# Access Compliance Report

## Public Rights-of-Way

Intersection ID: 28112	Main Street: PROVIDENCE_RD	Cross Street: BELICOURT_DR	Location: NW
ADA ID: 2AC72E5EF19D	Ramp Type: Para	Initial Pass/Fail: Fail	Overall Compliance: No
Codes/Mitigation Info/Possible Solution		Field Measurements/Component Compliance

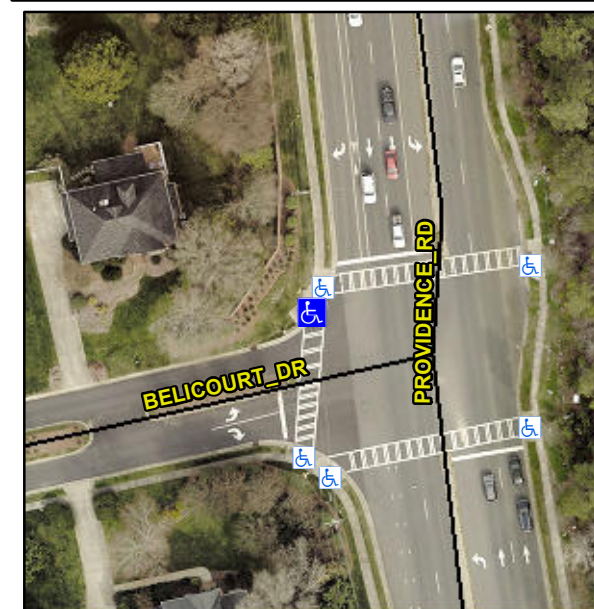
**LT RP < 5%**

**R304.5.3, R304.3.2**

**Remove & Replace Entire Ramp.**
